SERVICE BULLETIN AMATEUR RADIO

SUBJECT	DATE
TH-25/45 W/TSU-6 TONE ALERT IMPROVEMENTS	4/11/88

FIGURE 1

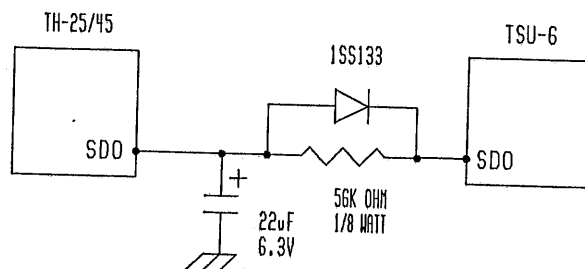
When using the TH-25/45 in combination with the TSU-6 you may experience erratic operation of the tone alert function. This may be due to an incoming signal that is over-modulated, distorted, or noisy. The following modification will correct this tendency.

22 μ F, 6.3V ELECTROLYTIC CAPACITOR	PART # CE04CW0J220J
56K OHM, 1/8W CARBON RESISTOR	PART # RD14BB2B563J
DIODE	PART # 1SS133

1. Remove the TSU-6 from the TH-25/45 (refer to the TH-25/45 instruction manual for details).
2. Cut the blue wire (pin # 4) approximately 5mm from the the connector for the TSU-6.
3. Solder the components to the blue wire and ground as shown in figure 1. Note that the cathode side of the diode goes towards the TSU-6 connector. Use the leg of the VCO shield to ground the negative side of the capacitor.
4. Insulate the components with electrical tape to prevent shorting.
5. Install the TSU-6 in the TH-25/45. Route the components so that the battery terminal plate does not bow when installed.
